**APPENDIX A. PUBLIC AND AGENCY COMMENTS AND RESPONSES MADE
DURING THE PUBLIC REVIEW PERIOD**

Re: AGFD Review of the West Kingman Traffic Interchange Draft EA

Figure 10 Traffic Volumes

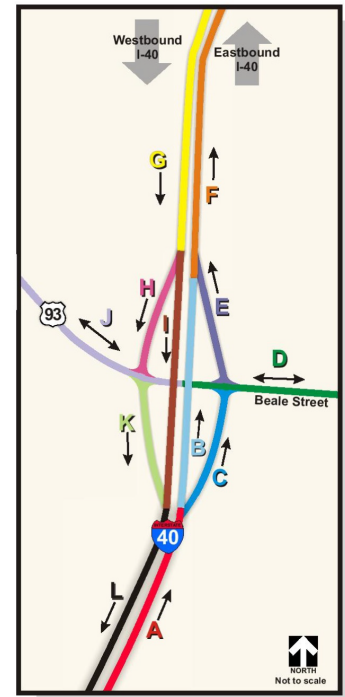
2006 data is inaccurate:
 Data for B =A-C=F-E; however A-C=6,166 & F-E =4,146.
 Therefore, 2,020 vehicles drove off I40 or were sucked off
 the road before "E" traffic merged.

Data for I=G-H=L-K; however, G-K =3,699 & L-K = 5,033.
 So, did 1,334 vehicles grow out of the pavement on the
 overpass?
